DA 2022/2148 – Response to Request for Information
Demolition works and construction of a building for use as a specialised retail premises including signage at 200, 202 & 204 Condamine Street, Balgowlah.

I refer to Council's letter dated 6 March 2023 for 200, 202 & 204 Condamine Street, Balgowlah. ('the site').

Figure 1. 3D image showing the breach to the building height in red (source: Centric Architects)

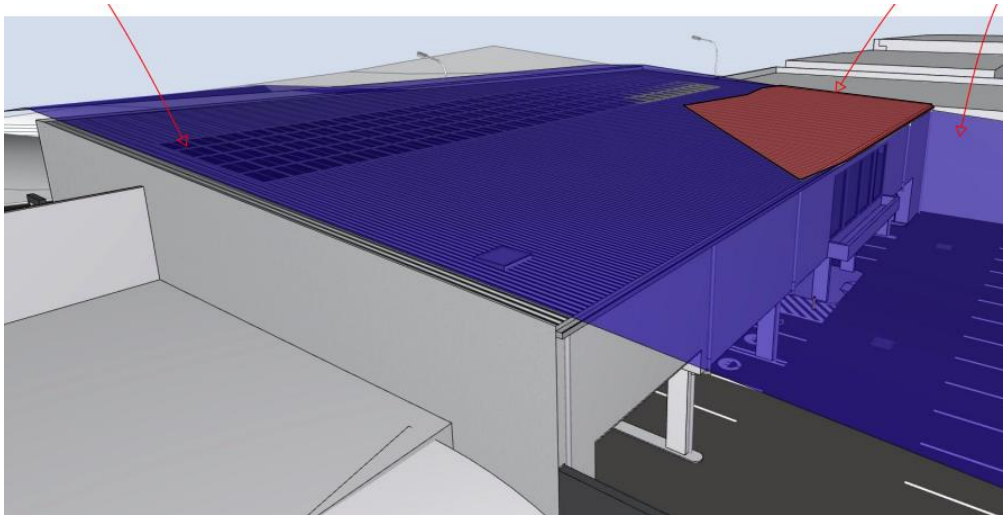
1. Building Height

The result is that the Condamine Street elevation is below the 11m building height plane. Only the north-eastern corner breaches the maximum building height. The breach has been reduced

from 1355mm to 497mm or 4.5%. The overall volume of building that breaches the building height has been approximately halved.

The breach to the building height (as amended) is shown in Figure 1 below:

The overall building height has been reduced as follows;

- Level 2 and the roof have both been lowered by an overall 400mm
- The roof pitch has been amended from 2 degrees to 2.8 degrees

Further, in consultation with the project engineers who have provided schematic structural and mechanical solutions, the roof cavity has been reduced. The cavity space provided is just enough to accommodate the structure and mechanical ducting and cannot be reduced any further.
